Accessible Housing: Drafting of proposed NCC changes

2020

This document outlines proposed changes to the text of the National Construction Code (NCC), which may be implemented if governments decide to proceed with regulation for a minimum standard for accessibility in new housing.

Figure G7.5 Measurement of clear opening width

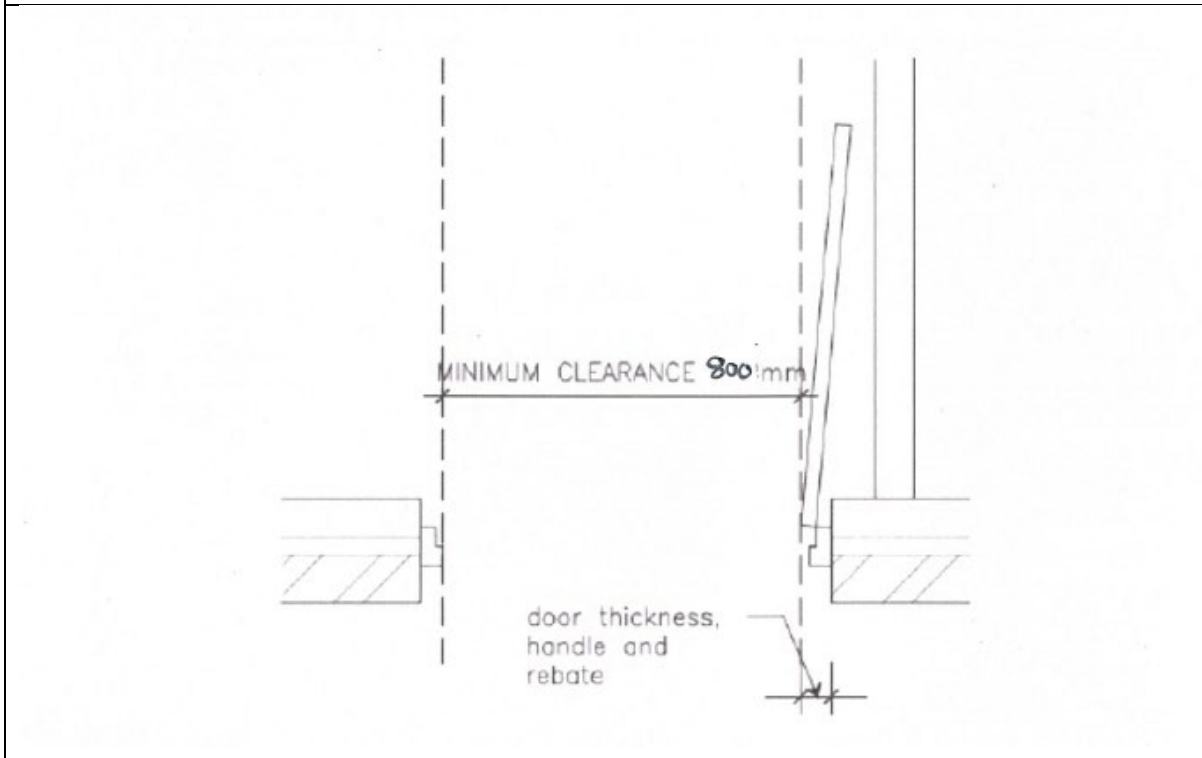
- (b) For the purposes of (a)(iii), minimum clear opening width is to be measured—
- (i) as shown in Figure G7.5; and
 - (ii) disregarding any door hardware that is located not less than 900 mm above finished floor level.

After new clause G7.5, insert new Figure G7.5 as follows:

Figure 3.9.3.5 Measurement of clear opening width

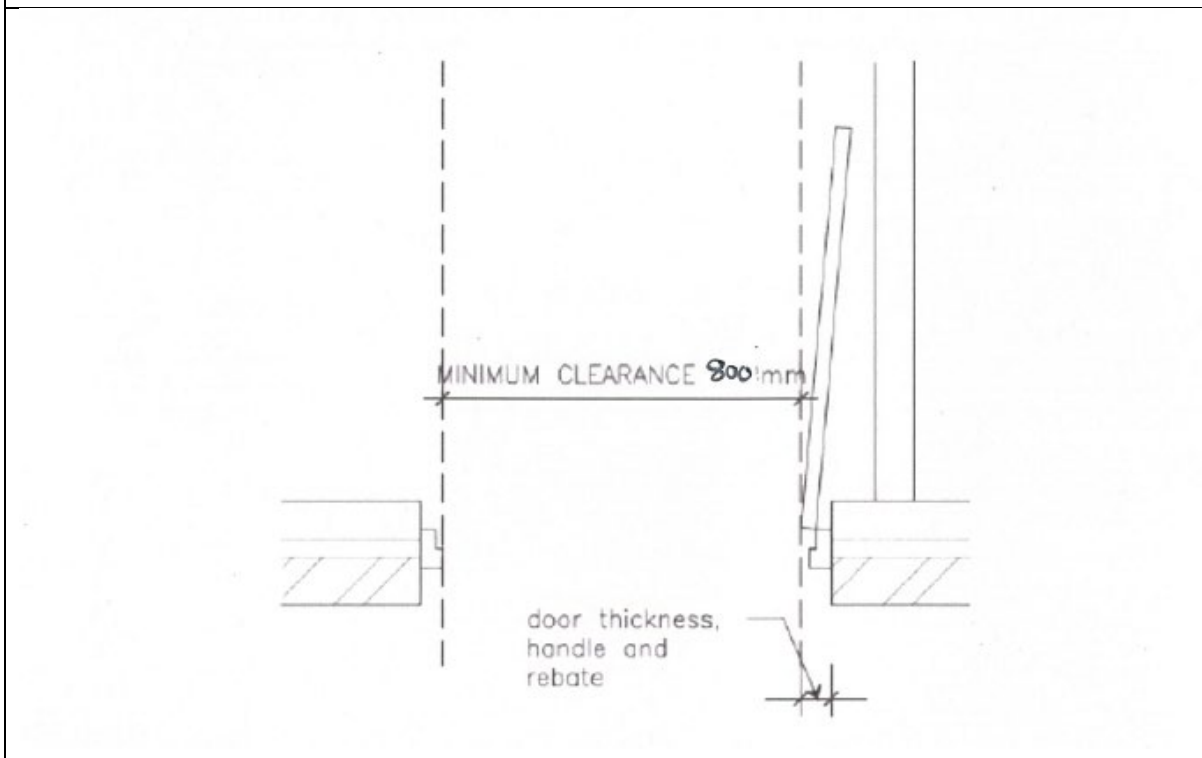
- (a) A Class 1a dwelling must include an entrance door with—
- (i) a minimum clear opening width of 800 mm; and
 - (ii) a level, step-free transition and threshold between abutting surfaces no higher than 5 mm provided the lip is rounded or bevelled, except as provided for in 3.9.4.4.
- (b) For the purposes of (a)(i), minimum clear opening width is to be measured—
- (i) as shown in Figure 3.9.3.5; and
 - (ii) disregarding any door hardware that is located not less than 900 mm above finished floor level.

After new clause 3.9.3.5, insert new Figure 3.9.3.5 as follows:

Figure F2.5 – diagram 2

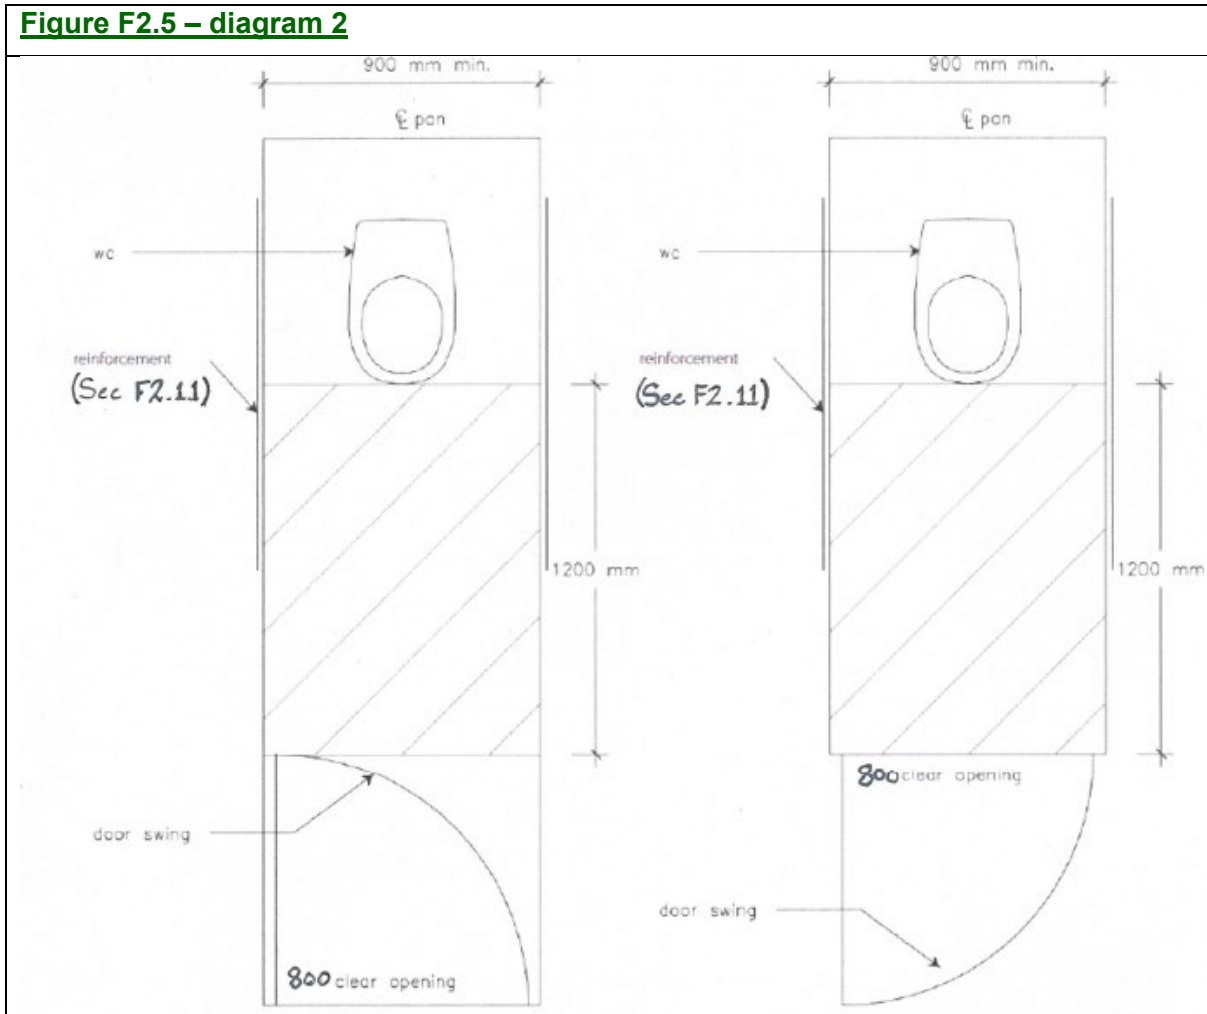
(iv) Compliance with (i), (ii) and (iii) must be determined in accordance with Figure F2.5 – diagrams 2 or 3.

Re-designate existing Figure F2.5 as Figure F2.5 – diagram 1, and insert new Figure F2.5 – diagram 2 (LHDG p 31) as follows:

Figure F2.5 – diagram 3

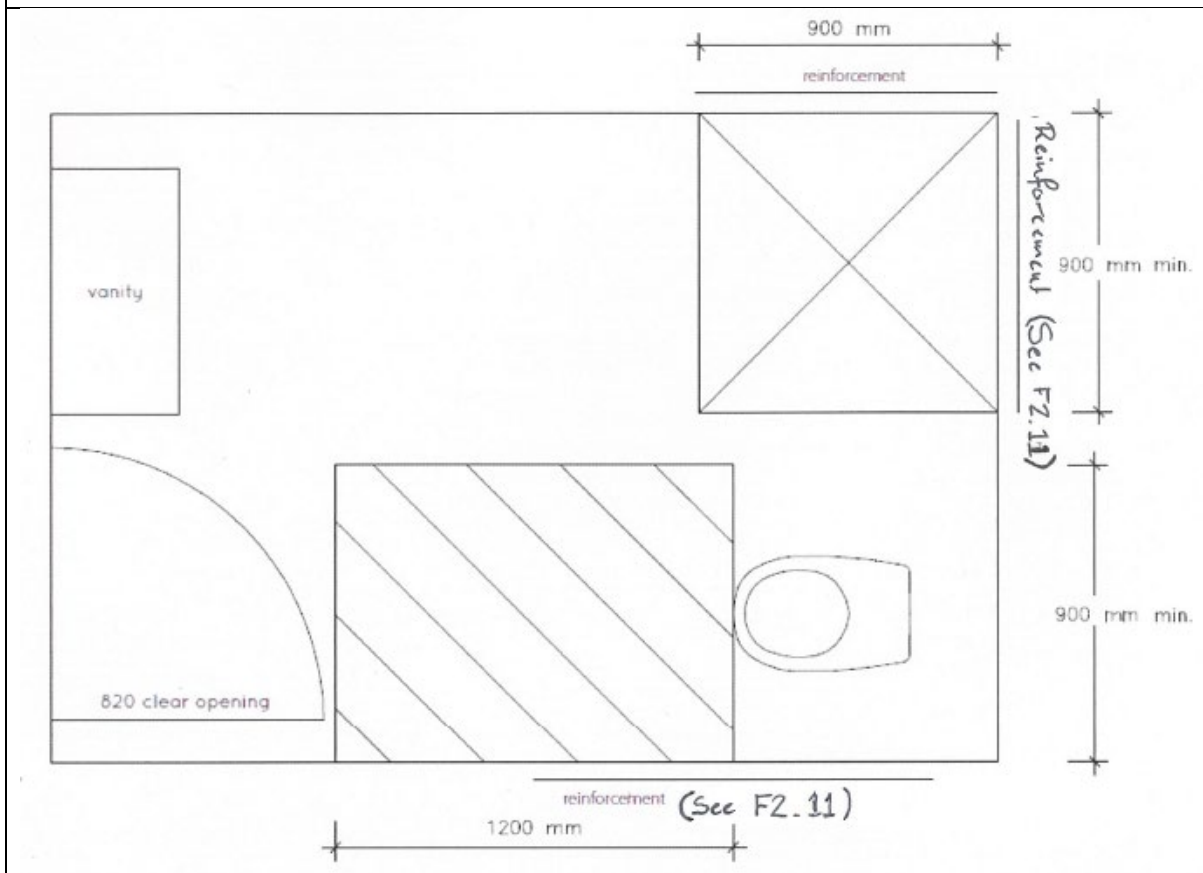
After new Figure F2.5 – diagram 2, insert new Figure F2.5 – diagram 3 (LHDG p 32) as follows:

Figure 3.8.3.3 – diagram 2

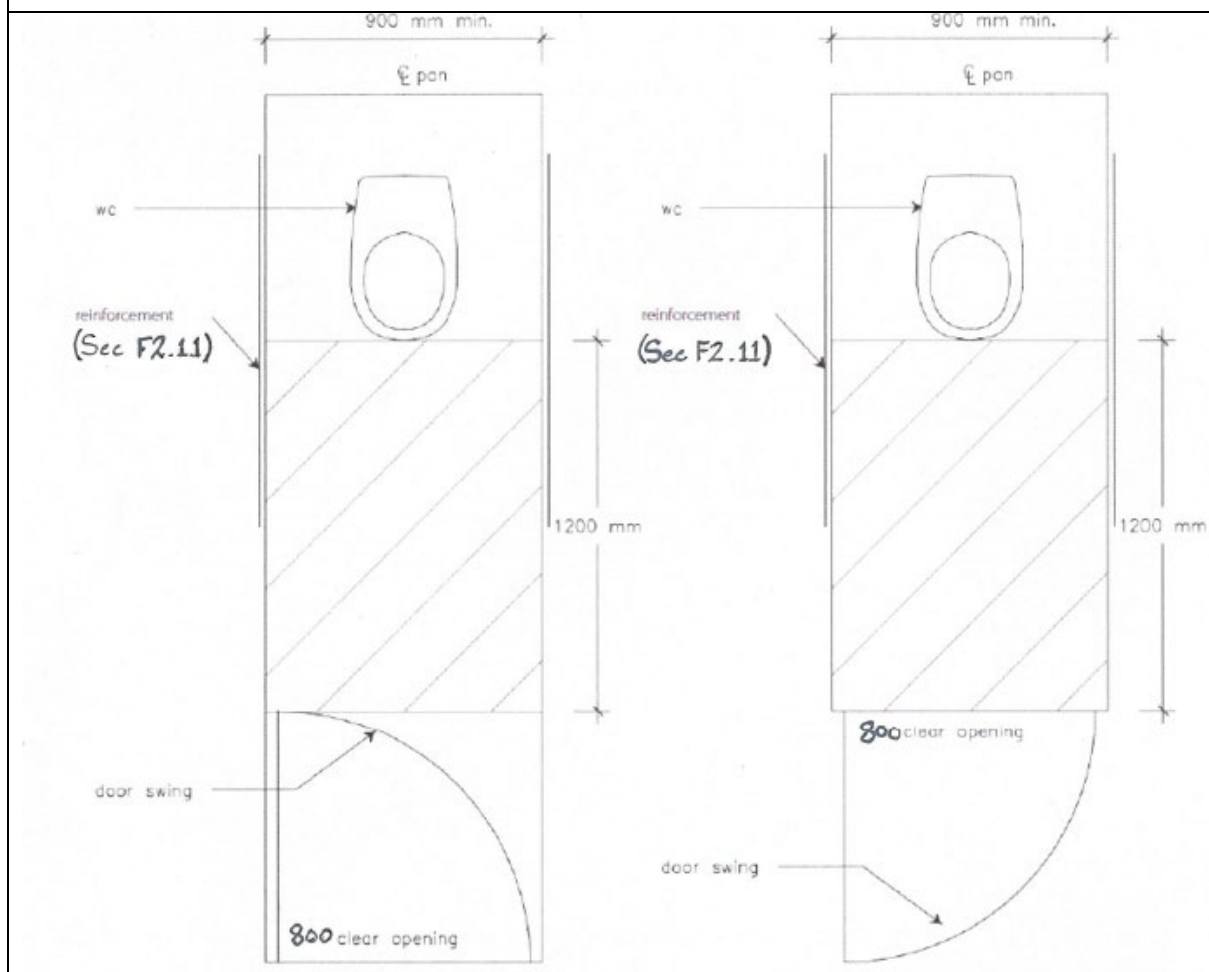
(B) for a sanitary compartment complying with (b), Figure 3.8.3.3 – diagram 2,

Re-designate existing Figure 3.8.3.3 as Figure 3.8.3.3 – diagram 1, and insert new Figure 3.8.3.3 – diagram 2 as follows:

Figure 3.8.3.3 – diagram 3

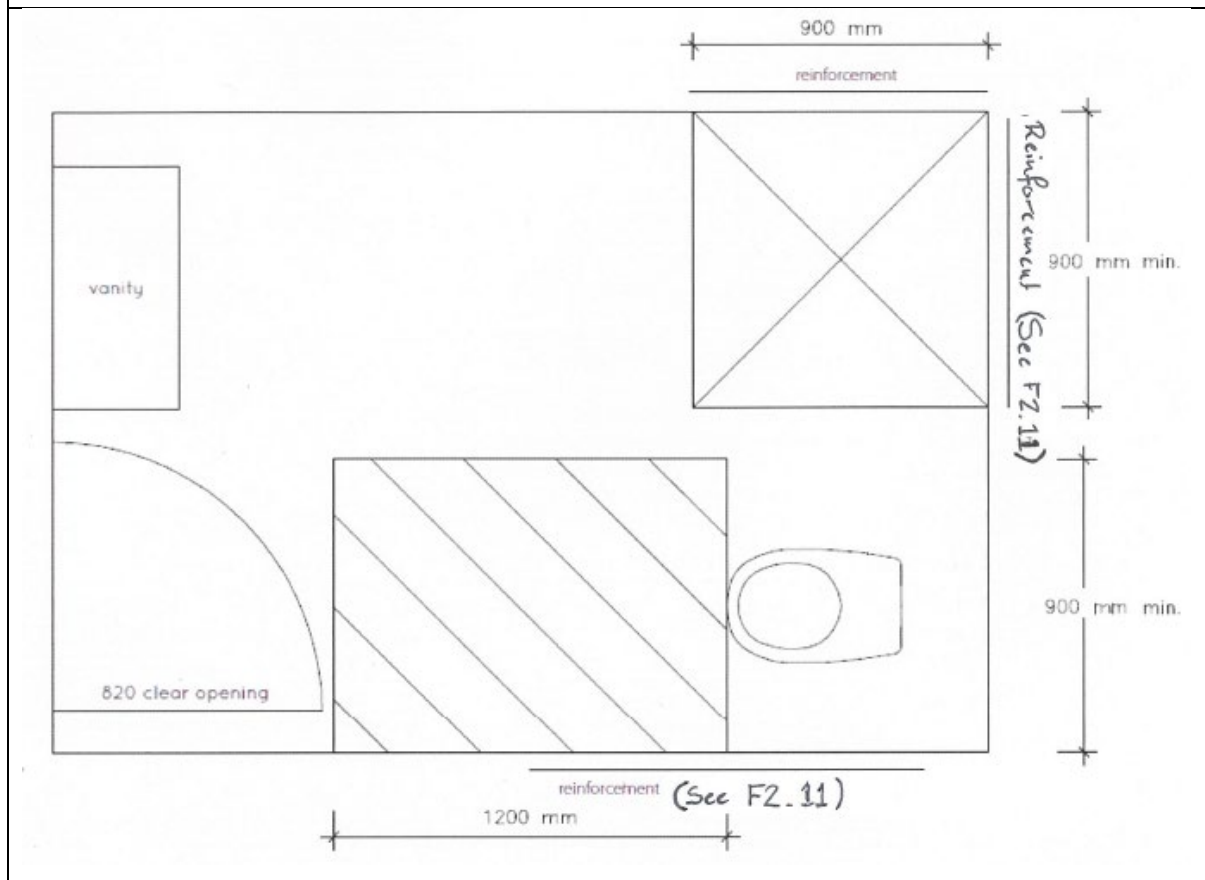
After new Figure 3.8.3.3 – diagram 2, insert new Figure 3.8.3.3 – diagram 3 as follows:

Figure F2.10 / 3.8.3.4

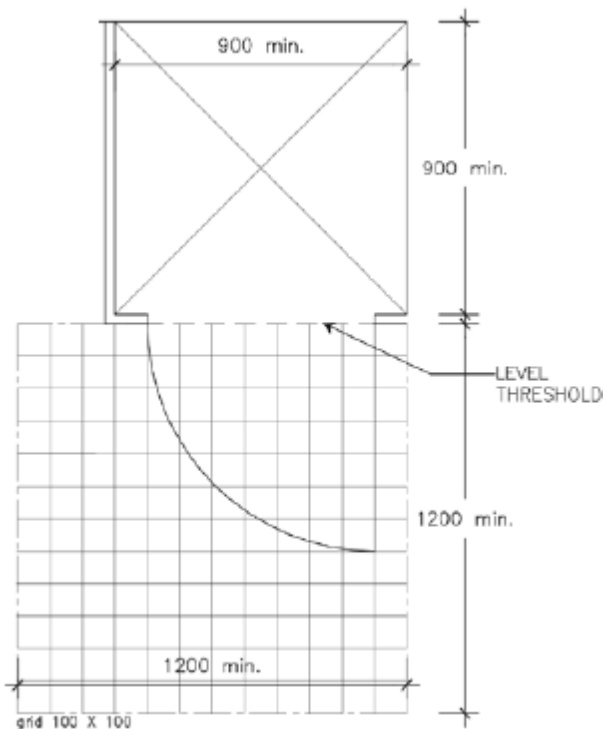
- (b) The height of any hob, raised step, kerb, step-down or the like, must not exceed 25 mm.
- (c) The shower recess must have minimum dimensions of 900 mm x 900 mm, with a clear space of 1200 mm x 1200 mm adjacent to the shower entry, as shown in **Figure 3.8.3.4.**
- (d) The shower must be located in a bathroom that is on the ground or entry level of the dwelling.
- (e) The requirements of (d) need not be complied with if the dwelling is a garage top dwelling for the purpose of **Part 3.7.4.**

After new clause F2.10 / 3.8.3.4, insert new Figure F2.10 / 3.8.3.4 as follows:

Diagram 1 – Location of noggings (closet pan)

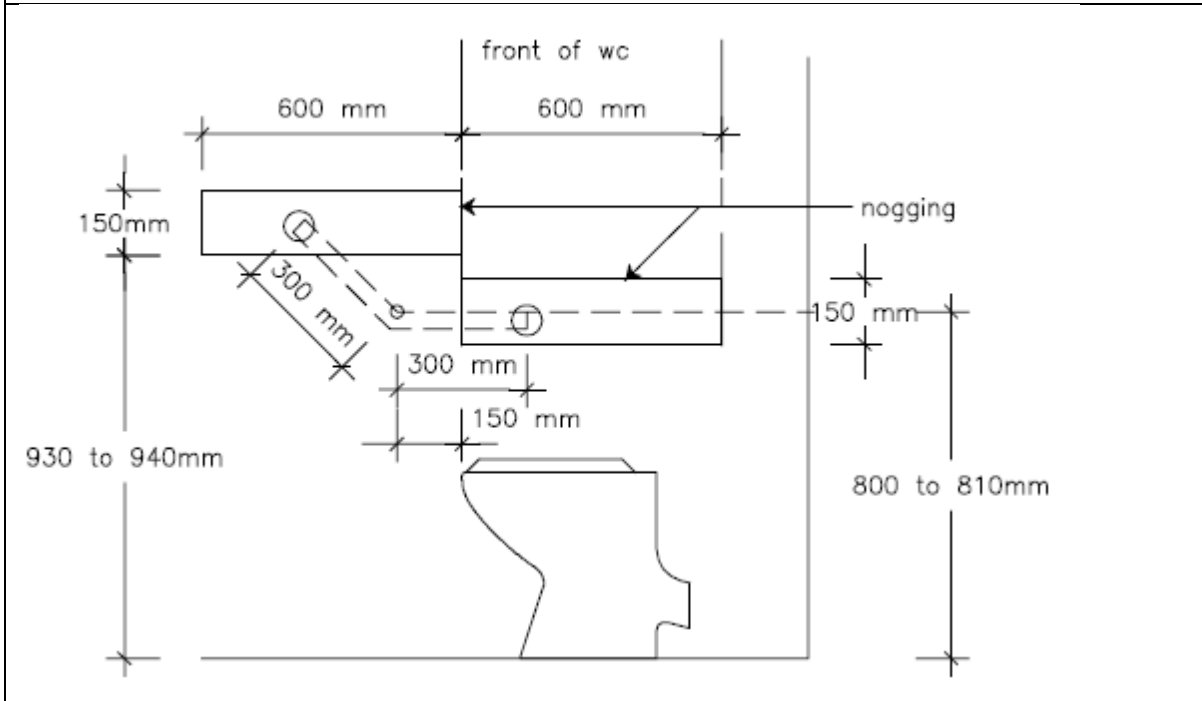
(A) noggings are installed in the locations shown in **Figure F2.11 — diagram 1**; or

After new clause F2.11 / 3.8.3.5, insert new Figure F2.11 / 3.8.3.5 as follows:

Diagram 2 – Location of sheet reinforcing (closet pan)

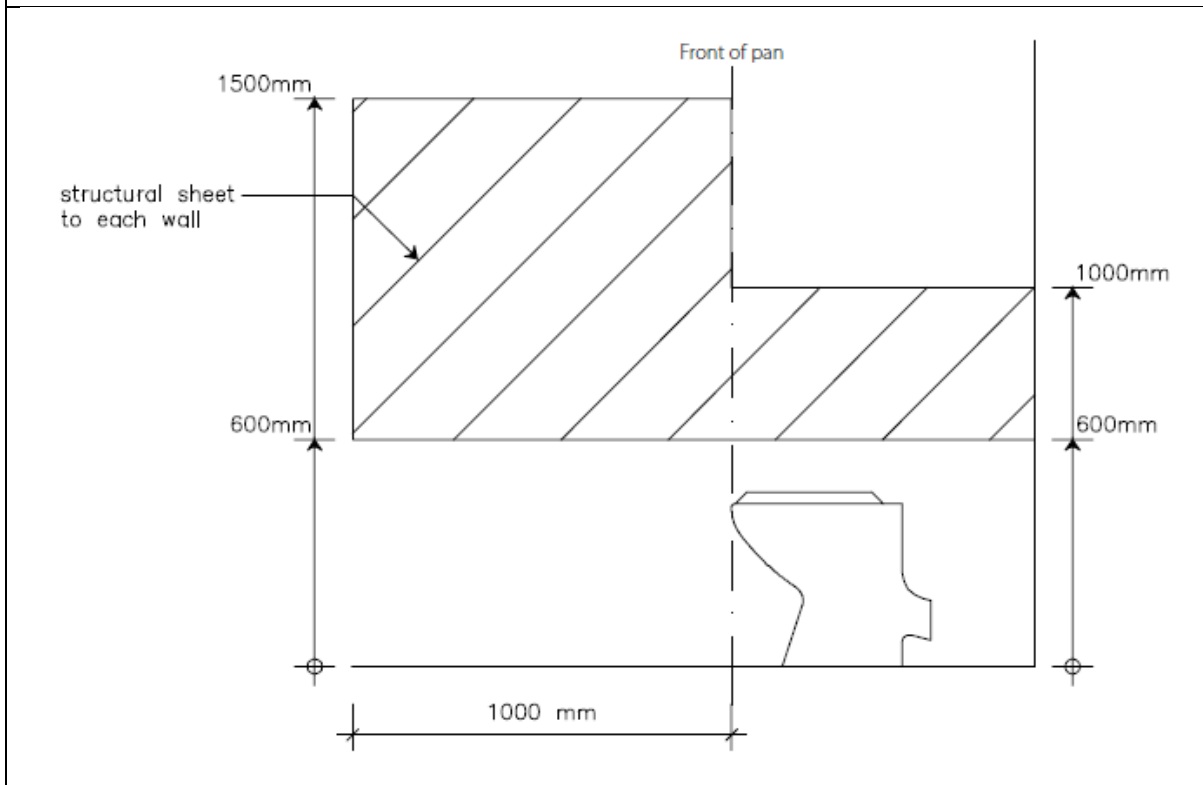
(B) plywood sheeting is installed in the locations shown in **Figure F2.11 — diagram 2**; and

After new clause F2.11 / 3.8.3.5, insert new Figure F2.11 / 3.8.3.5 as follows:

Diagram 3a – Location of noggings (shower—rear wall)

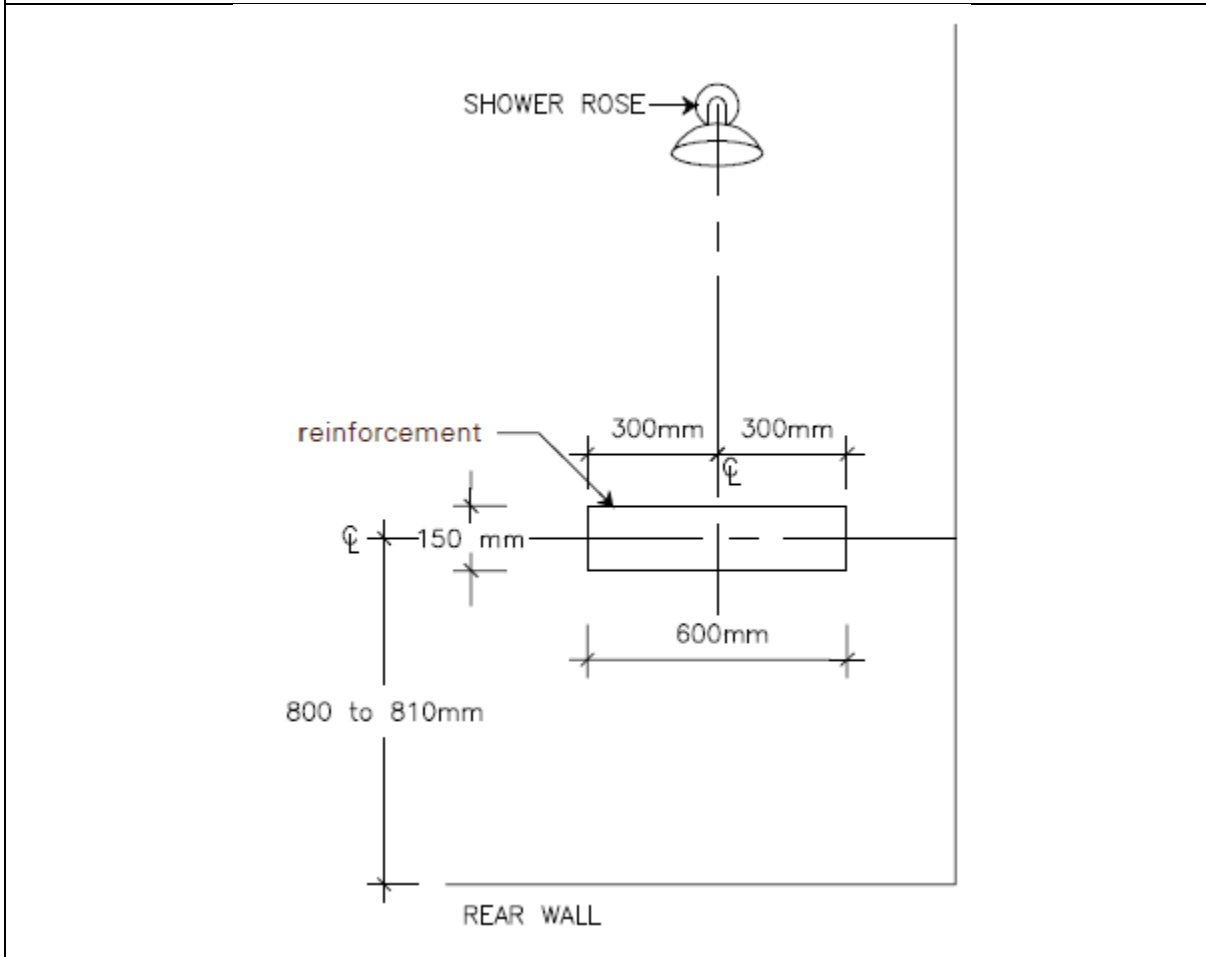
- (A) noggings are installed in the locations shown in **Figure F2.11 — diagrams 3a, 3b or 3c**; or
- (B) plywood sheeting is installed in the locations shown in **Figure F2.11 — diagram 4**; and

After new clause F2.11 / 3.8.3.5, insert new Figure F2.11 / 3.8.3.5 as follows:
